Upper and Lower Connections of Side Frame of Single Side Bulk Carrier

Lloyd Register Asia
Yokohama Design Support Office
16 January 2008

Fig.5 (b) Bending Stress in Side Frame in way of Lower Bracket

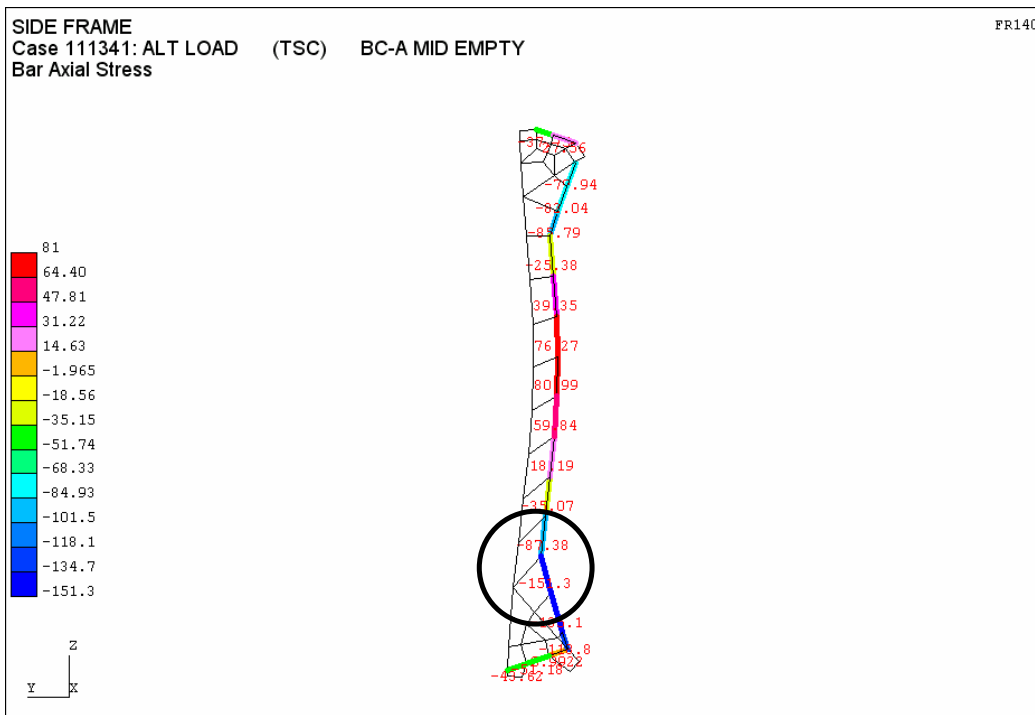
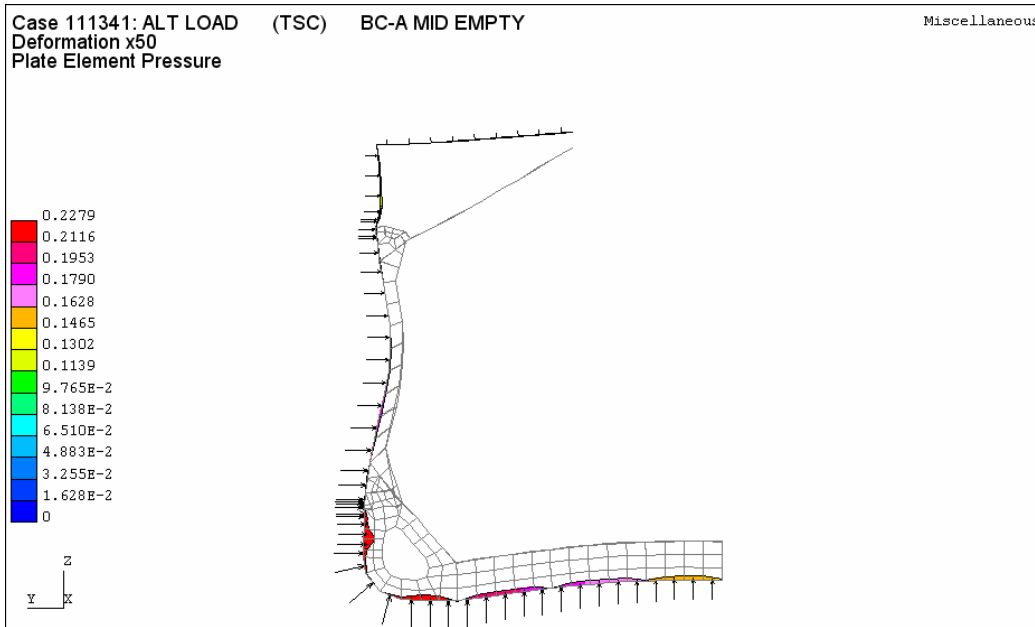
1.3.3 The bending stress distribution along the span of the side frame is observed in Figs. 5 (a) and (b). The boundary conditions at both ends of the frame are considered almost as fully fixed.

2.2 Eq.(1) in the TB gives us a turning moment at each end of the side frame which is induced by the pressure working over the span of the frame. The coefficient of α_T in Eq. (1) depends upon the boundary condition of the frame at the end. For fully fixed end, α_T will be 83.3, i.e., 1000/12. This value is compared with 75 at the upper end of the frame and 150 at the lower end of the frame. Ch. 6, Sec. 2, Para. 3.4.1 is referred to for these Rule values. Taking into account the FE analysis result as stated in Para. 1.3.3 above, the value of 150 at the lower end is considered too much severe.

Fig. 6 Net Scantlings Complying with Rule Change Proposal

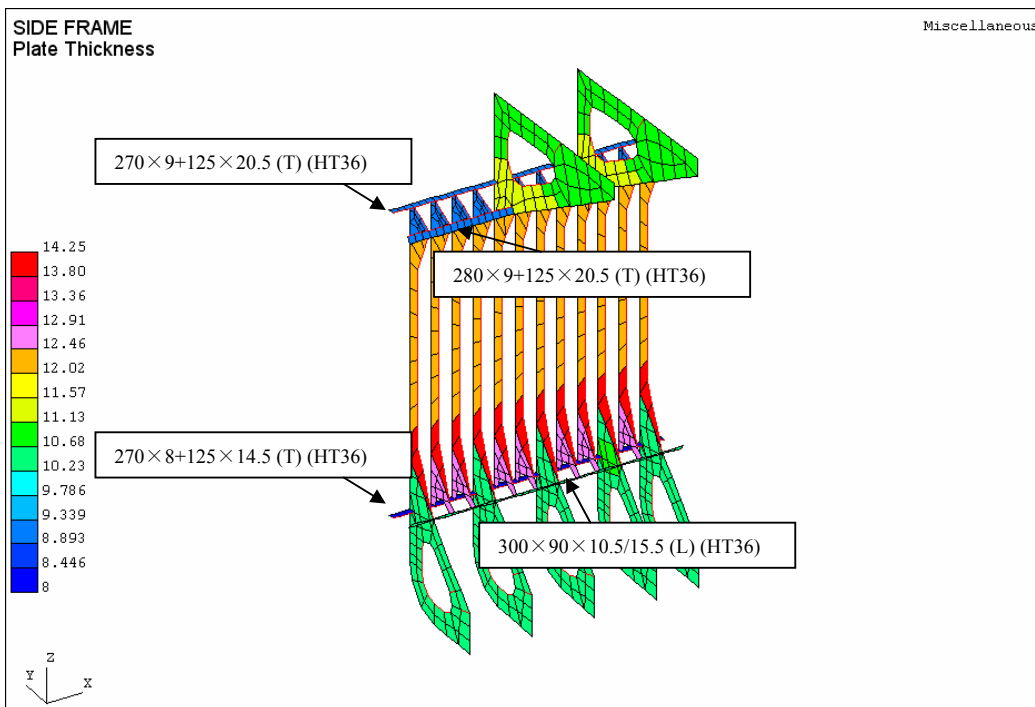
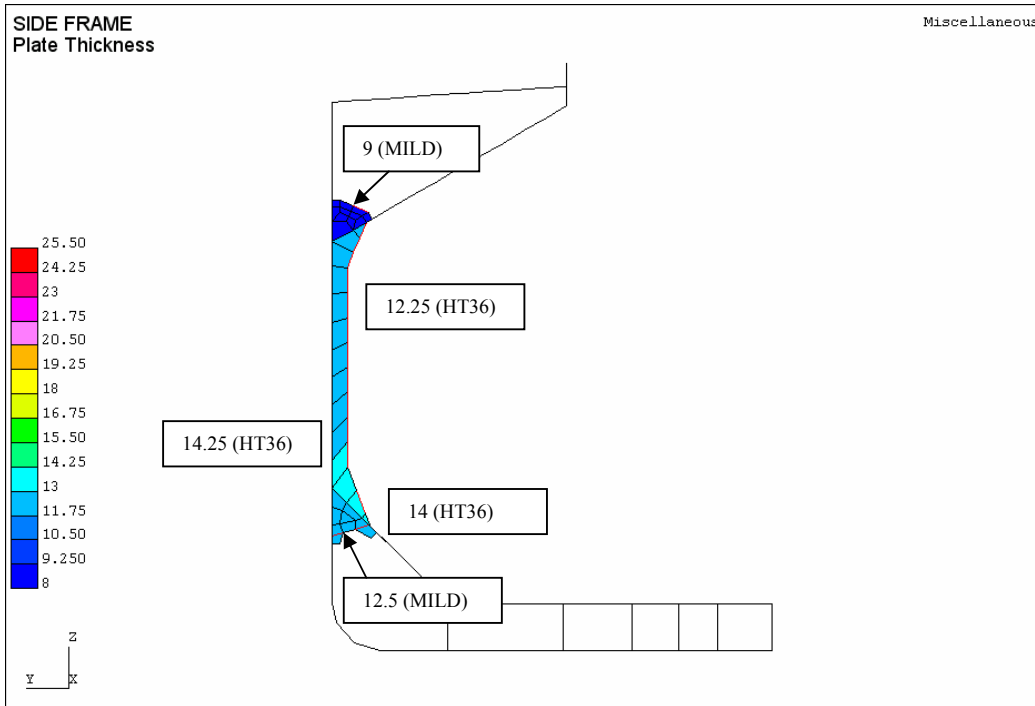
4.1 To verify the Rule change proposal, another FE structural analysis has been carried out using the model in which the proposed scantlings have been integrated as shown in Fig. 6.

3.1 Taking into account the consideration above, the following Rule change proposal is made for Ch. 6, Sec. 2, Para. 3.4 of the Rules;

3.1.1 For the formula giving us the required section modulus of the longl stiffener,

$$\sum w_{pi}d_i \geq \gamma_M \alpha_T (p_s + p_w) l_f^2 l_1^2 / (16 R_y)$$

where $w_{pi} = 1.4 w_i$

$$\gamma_M = 1 - (500/\alpha_T) (d/l_f)^2 \approx 0.80$$

$\alpha_T = 85$ at the lower end of the side frame
 $= 75$ at the upper end of the side frame

3.1.2 For the formula giving us the required shear area of the supporting bracket,

$$A_i = 0.32 w_i s k_{bkt} / (l_1^2 k_{lgi})$$

3.1.3 For the minimum net thickness of the supporting bracket, given from the formula in Ch.6, Sec.4, Para. 1.5.

Net thickness is to be not less than $0.6 \sqrt{L_2}$

where $L_2 =$ Rule length L , but to be taken not greater than 300m
